***TECHNICAL SPECIFICATIONS
PUBLICATIONS LIST
RECALL CAMPAIGN
SERVICE BULLETIN INDEX***

**328 / 328
GTB / GTS**

Ferrari Servizio Assistenza Tecnica

FERRARI NORTH AMERICA

Fig. 1 - Old Type Oil Sump and Suction Pipe

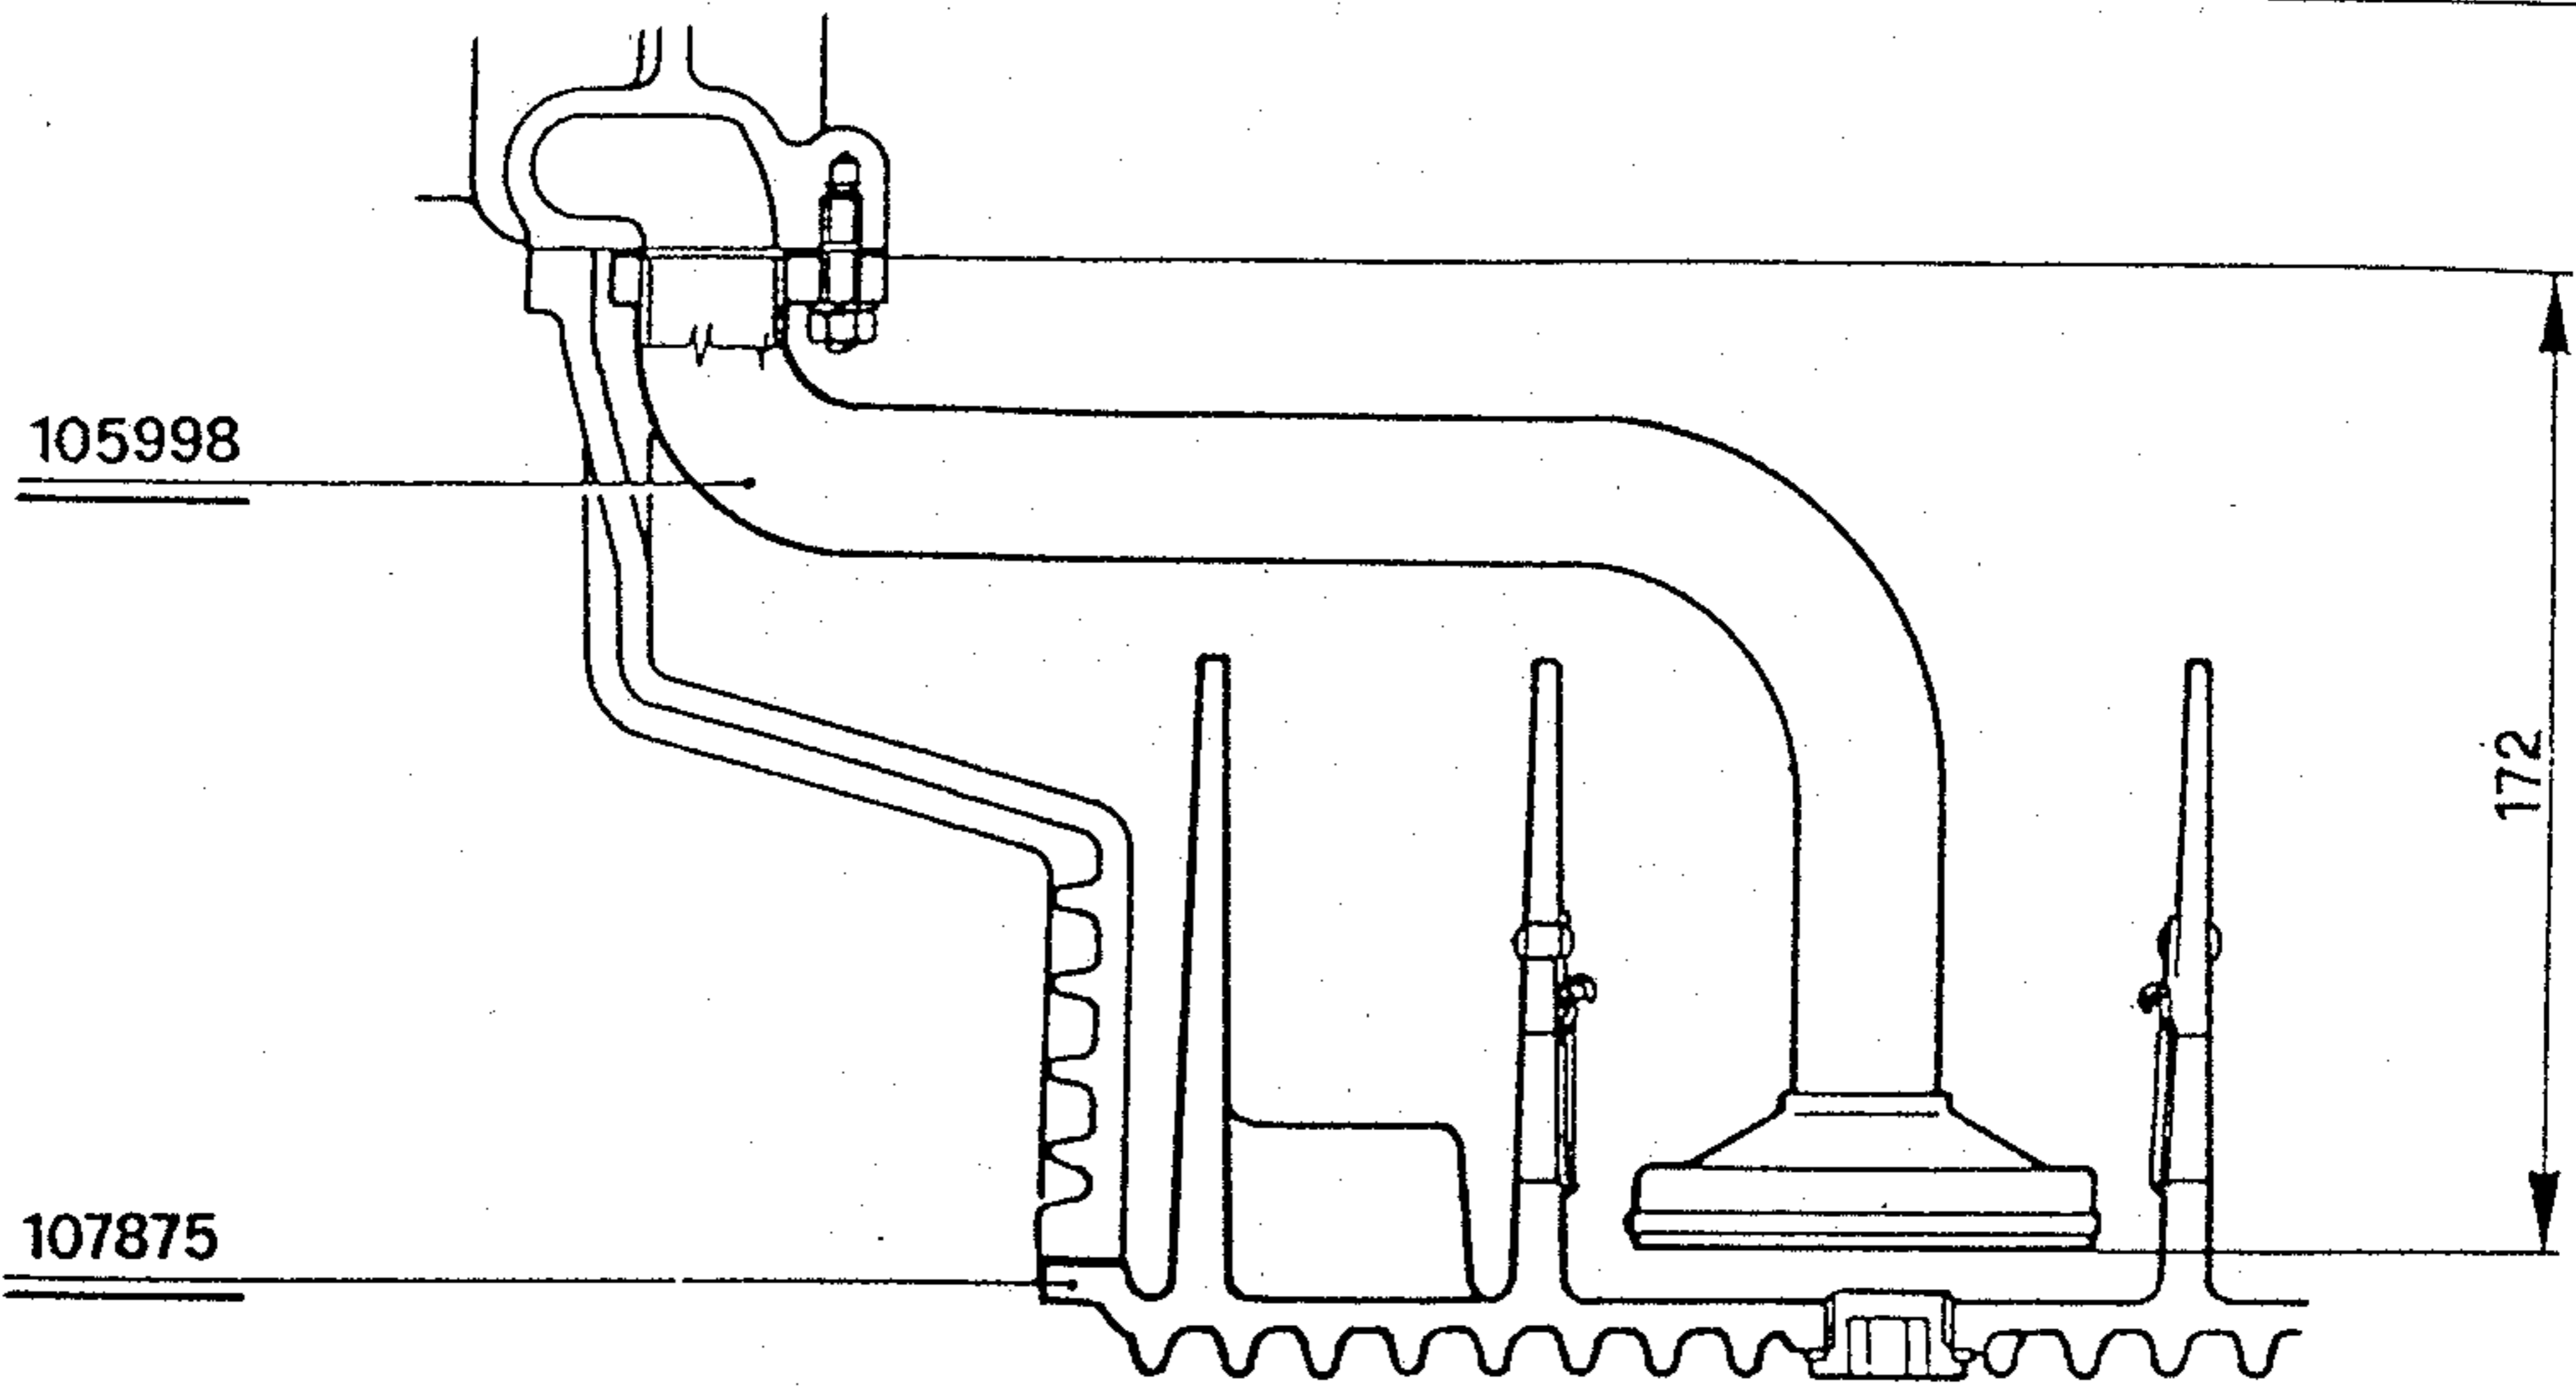
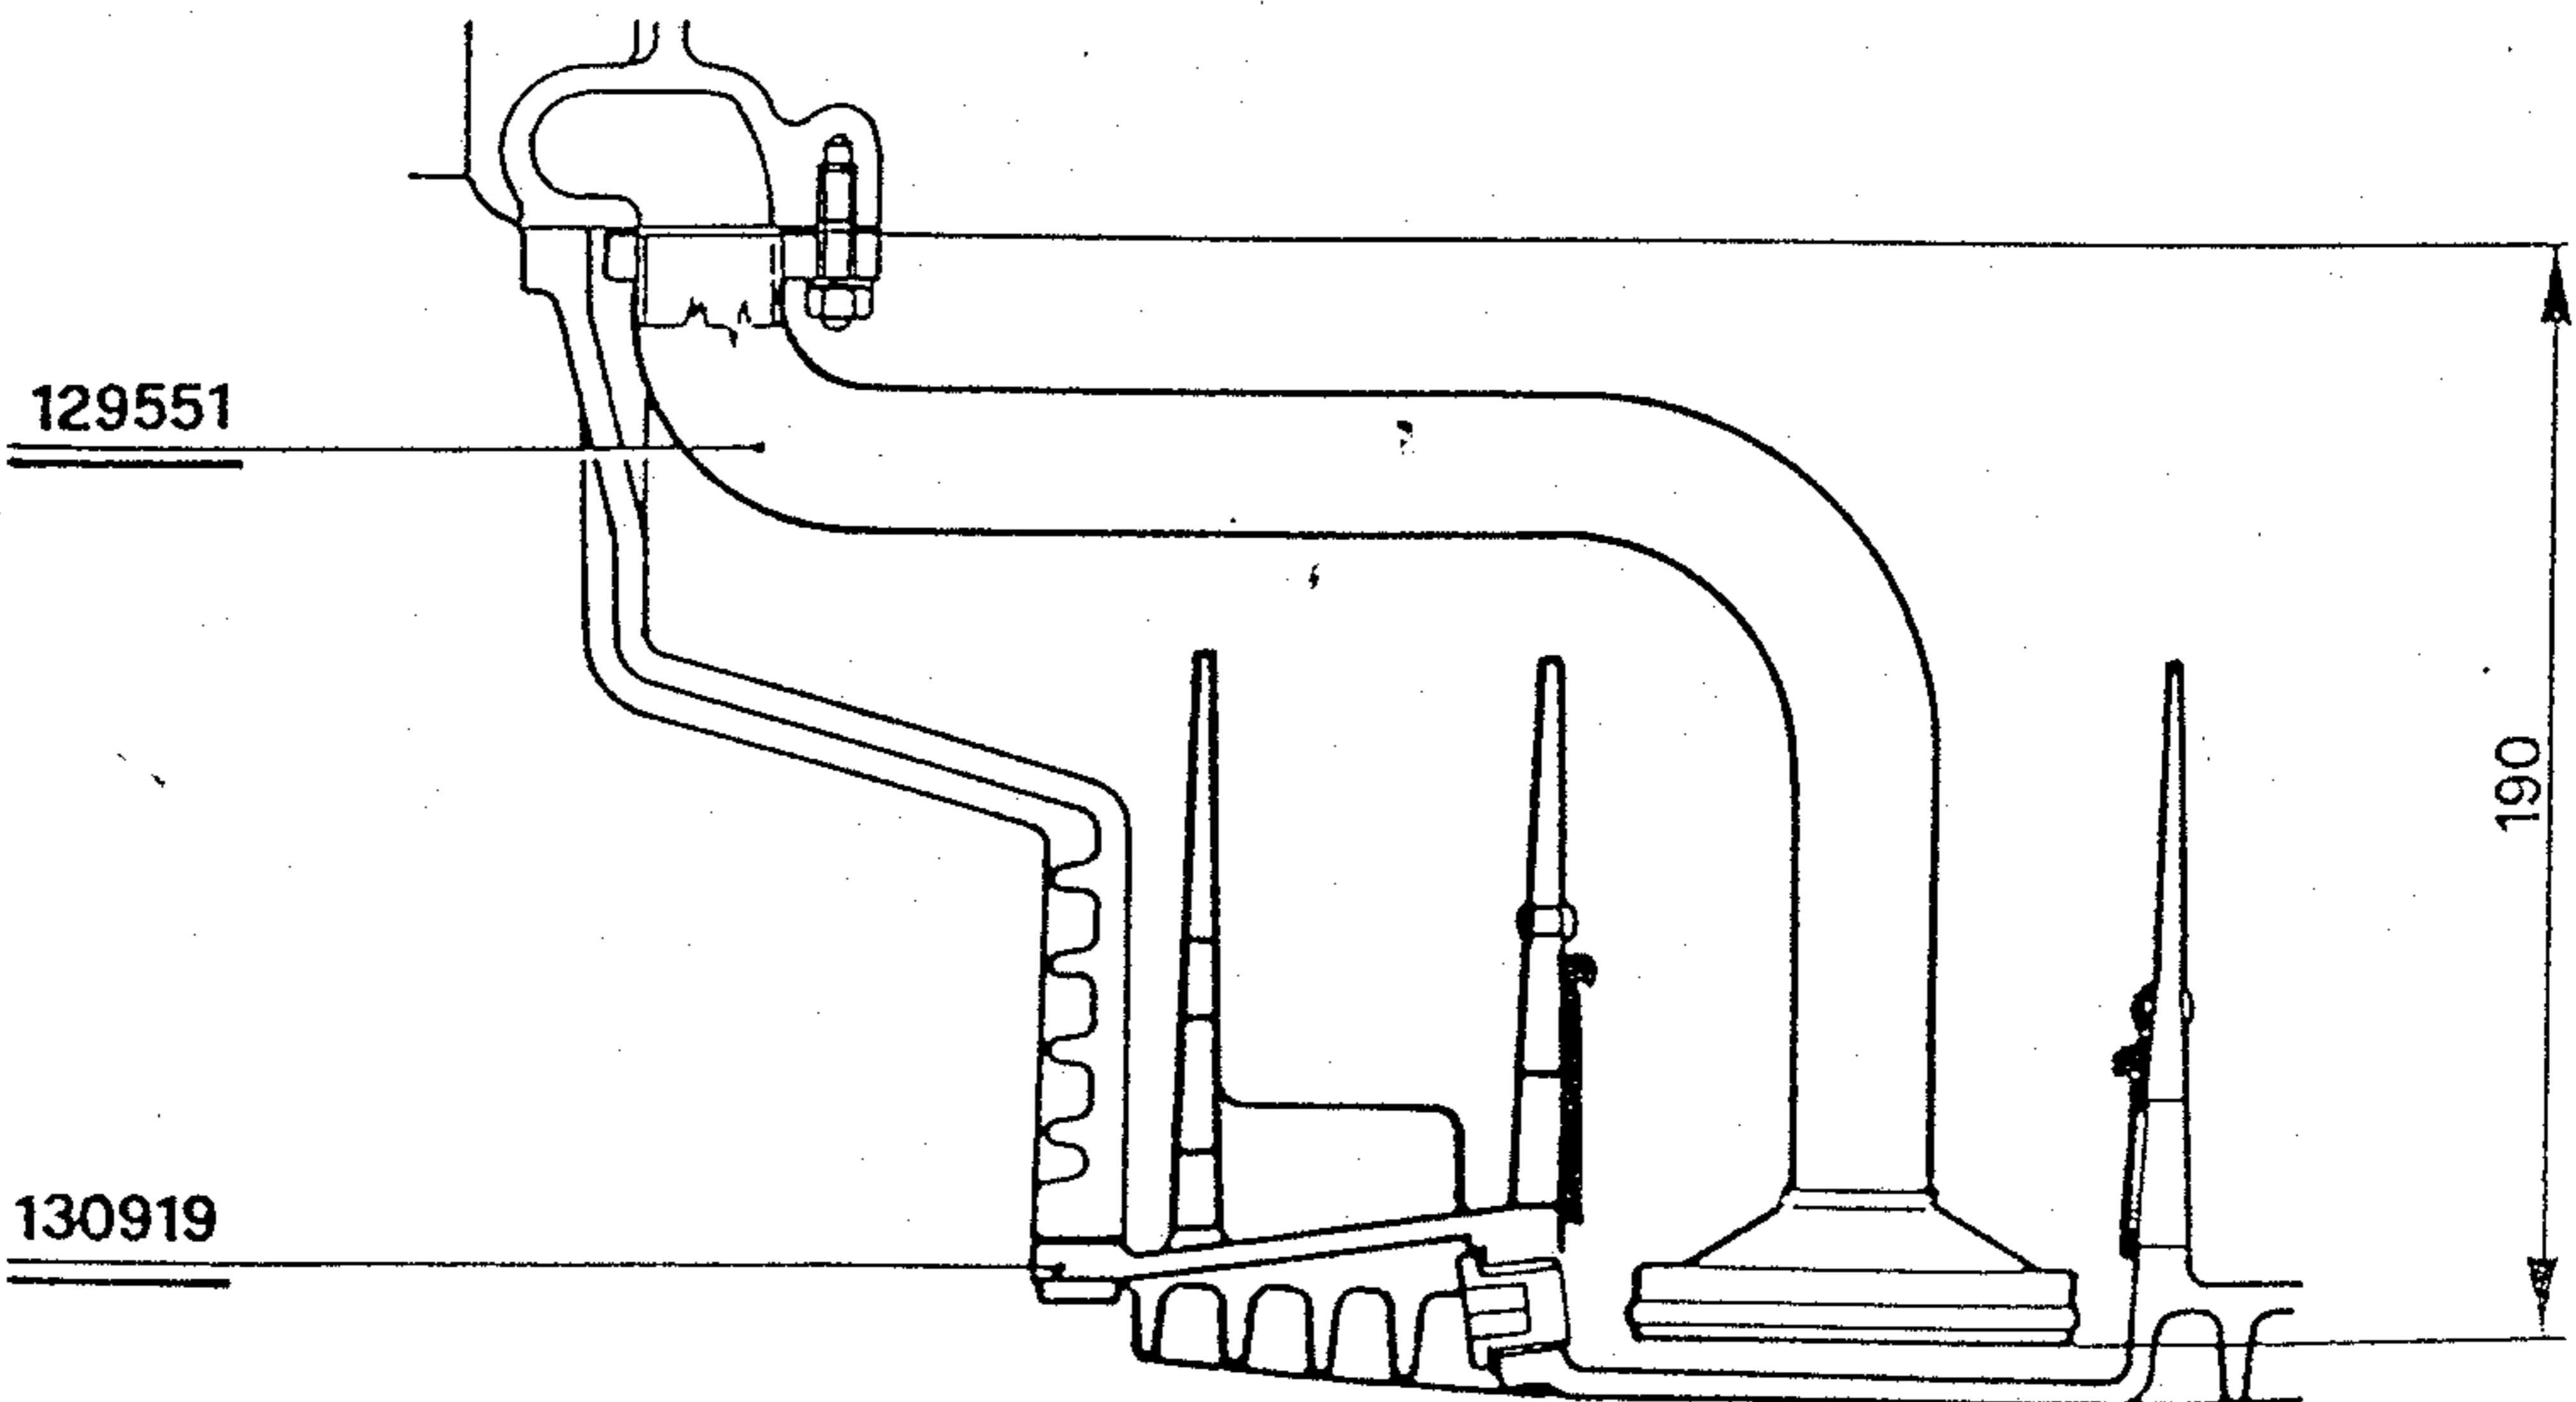
- either to replace the oil sump with a new one (solution to be preferred);
- or to install on the new engine the old type suction pipe.

Fig. 1

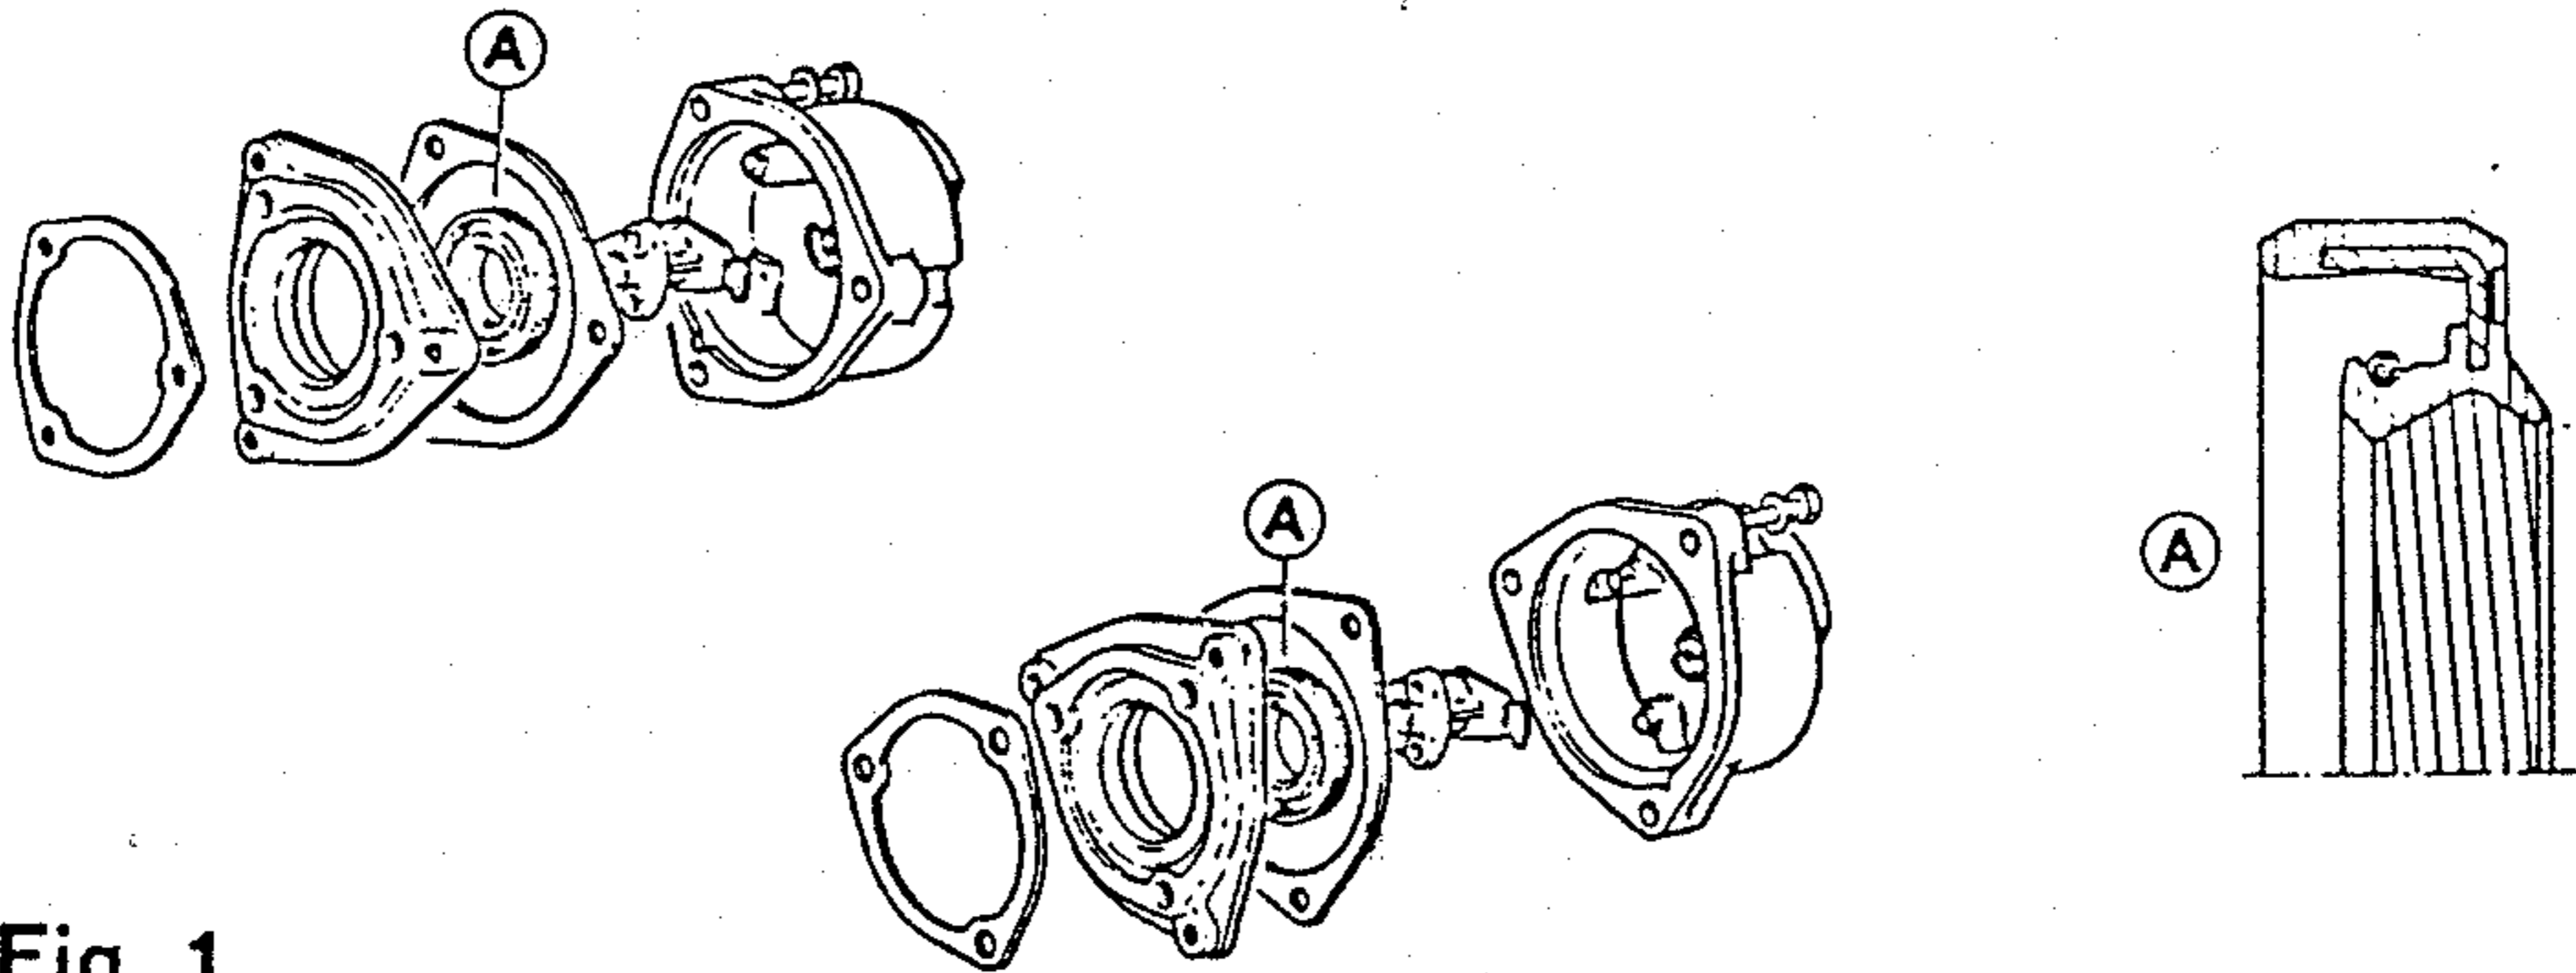
A new oil seal, with double lip, for ignition distributor (ref. A, Fig. 1) has been studied and introduced into production.

Fig. 4

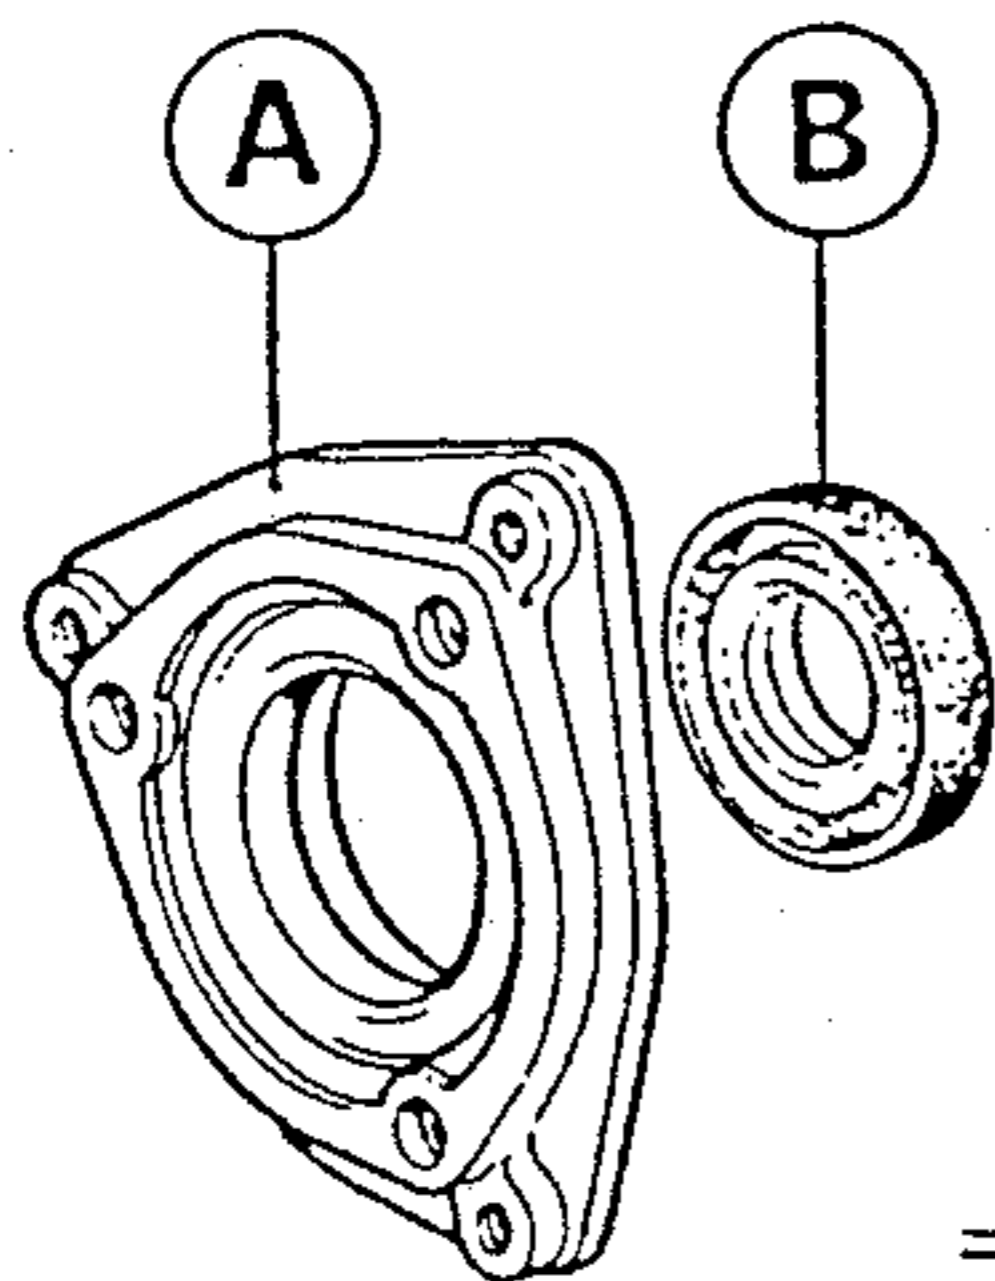
NOTE: The parts shown by Figure 4 have been introduced into production.

Also in this case, for replacement of the seal originally installed, employ only the new seal p.n. 132453. For this purpose, you shall also install the new mounting flange for ignition distributor (p.n. 133100), as shown by Figure 4 (also the early type flange P.N. 126115 can be utilized with the 1.25mm spacer, P.N. 133066).
